Technical change to M23 connector 1170290000 - SAI-M23-KSW-L-7/12

The product 1170290000 - SAI-M23-KSW-L-7/12 will be changed after a transitional period.
Please pass on this Product Change Notification (PCN) to your employees and, if applicable, to your customers.

Previous dimensions	New dimensions

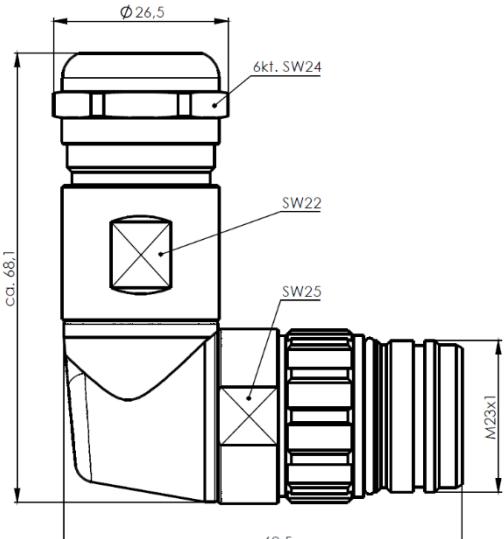
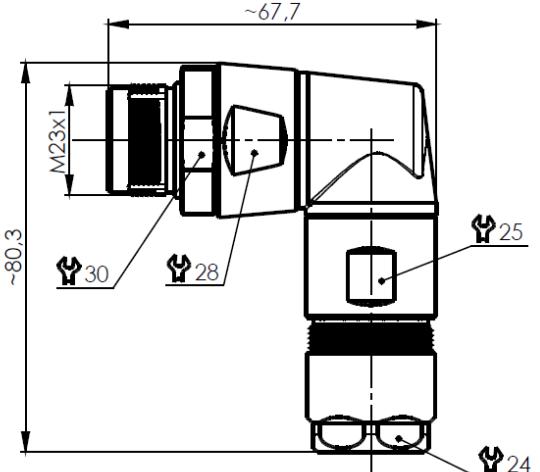
The option to rotate the cable outlet has been added to the connector to optimise processing.

Due to the product changes, the dimensions of the connector will change as follows:
